# TOWN OF SIDNEY

# Report to Advisory Planning Commission

SUBJECT: Development Permit Application No. DP100856

2436 Ocean Avenue

# Site Plan & Zoning Analysis

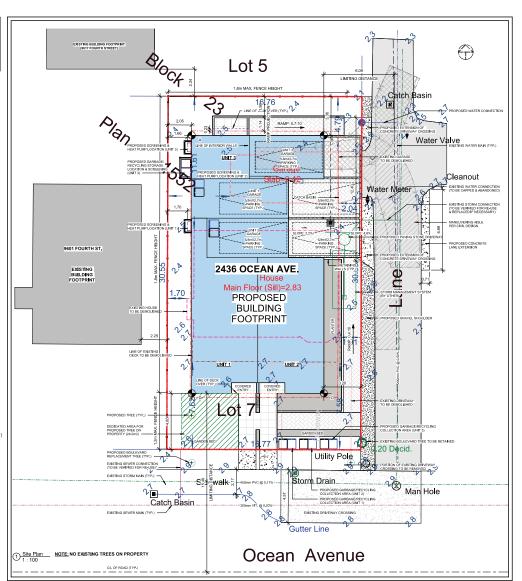
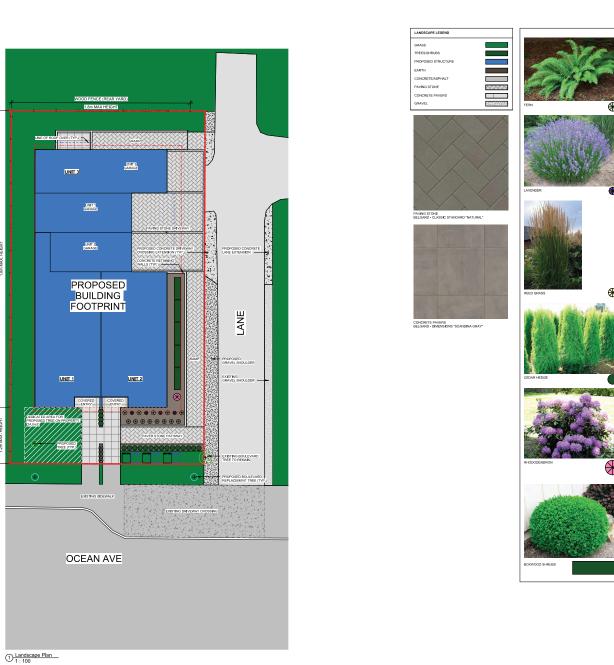
This property is situated uniquely, where it fronts Ocean Avenue and has vehicular access off the east side of the property via the lane. While the building is mainly oriented towards Ocean Avenue, it is designed in a way that continues to provide visual interest along the portion of the property facing the laneway.

- 25.4.12 Window openings on sidewalls should be planned to avoid aligning with windows of adjacent dwellings.
  - Consideration has been given in the design to off set the windows along common lot lines in order to maintain privacy. Windows along the west side of the property are arranged in a way so they are off set from the existing adjacent building (as well as the proposed building under Development Permit Application No. DP100855) to minimize direct sightlines into the neighbouring property to the east. Minimal window openings at the rear of the property help to reduce overlook into the adjacent property to the north. Balconies are oriented towards the street, which help to avoid impacts to the privacy of neighbouring properties.

- 25.4.21 Use textured, permeable paving for hard surfaced areas such as walkways, patios, driveways, and parking areas.
- 25.4.22 Hard-surfaced driveways and parking areas should be surfaced with materials that avoid a monotonous appearance.
- 25.5.2 A hard-surfaced connection should be provided between the dwelling and the street or lane. Parking areas and the pathway along the east side of the property are proposed to be surfaced paving stones. The entryways for each unit are to be surfaced in concrete pavers, as well as the path from Units 1 and 2 to the sidewalk. Parking areas for each unit are to be delineated by borders to add visual interest.

Development Perspectives

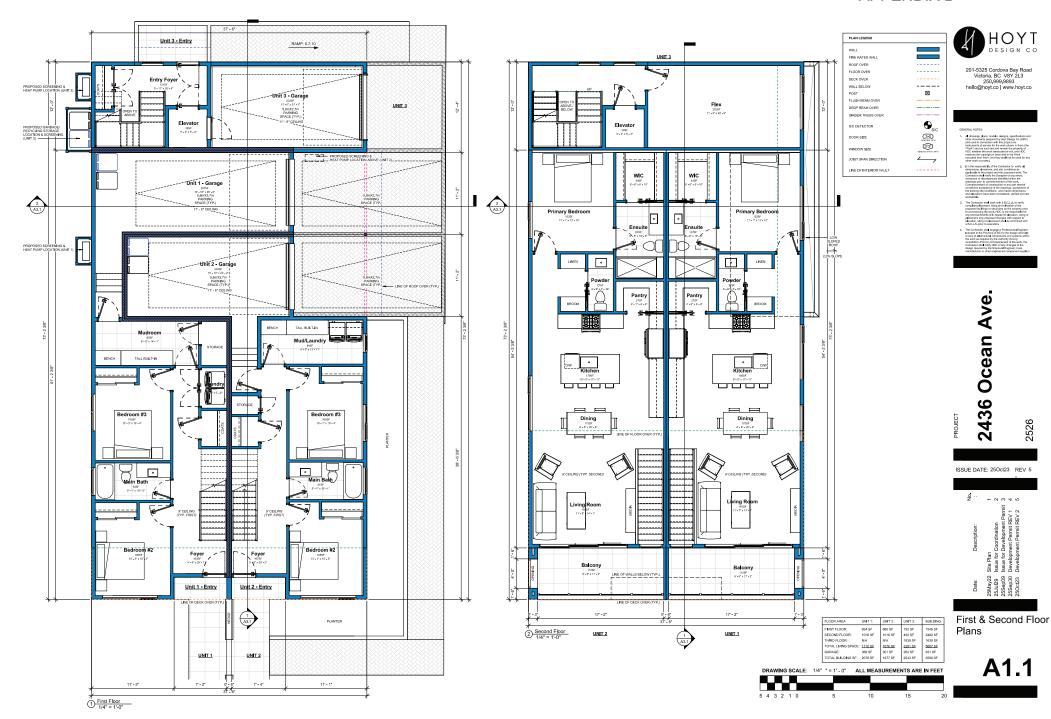
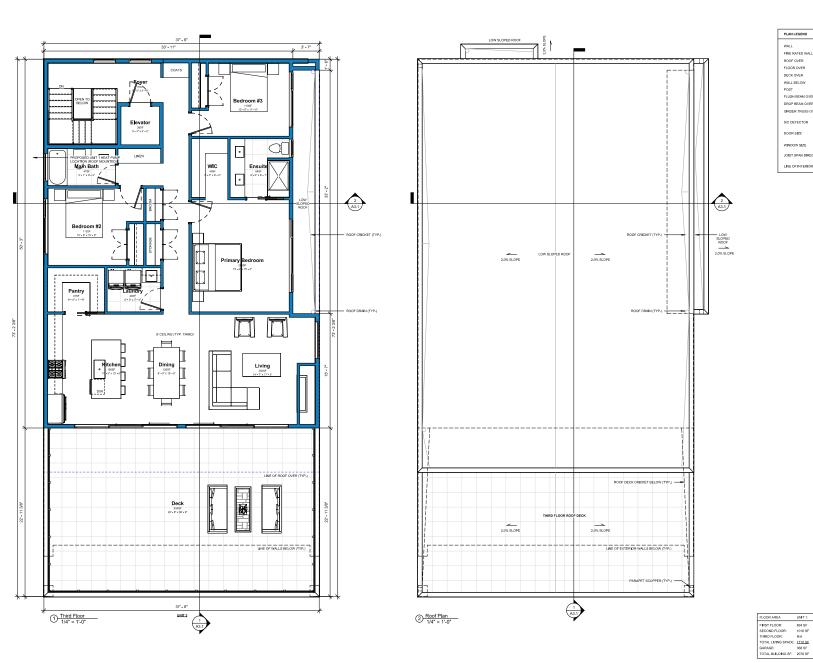
The building's design maximizes solar access, with all private balconies for each unit oriented southward. Lower balconies are recessed and the eaves on the third storey project to allow for shading and weather protection. A deciduous tree is proposed to be planted on the south side of the property, which will eventually help to provide shade to Unit 1 when it is mature.

Avenue were constructed under previous zoning regulations that only permitted up to 2.5 storeys. The proposed building manages this transition in height and natural grade by incorporating a step back at the third storey; this helps to reduce the perceived massing of the building, making it appear more consistent with the established scale of the neighbourhood.

Visual interest and definition are created along the main street frontage through strategic shifts and massing inherent to the building, specifically the use of recessed entries and balconies and the stepped back third storey. Consistent material and colour applications on all building elevations contribute to a defined and engaging presence to the streetscape.

- 25.3.42 Building materials should be used consistently throughout all building elevations that are visible from the street and public open spaces.
  - Building materials are used consistently throughout each elevation. The building uses a combination of shiplap composite siding and stucco in various shades of grey, accented with metal along the edges of the building. The south side of the building include large windows and is complemented with glass and aluminum guard rails.
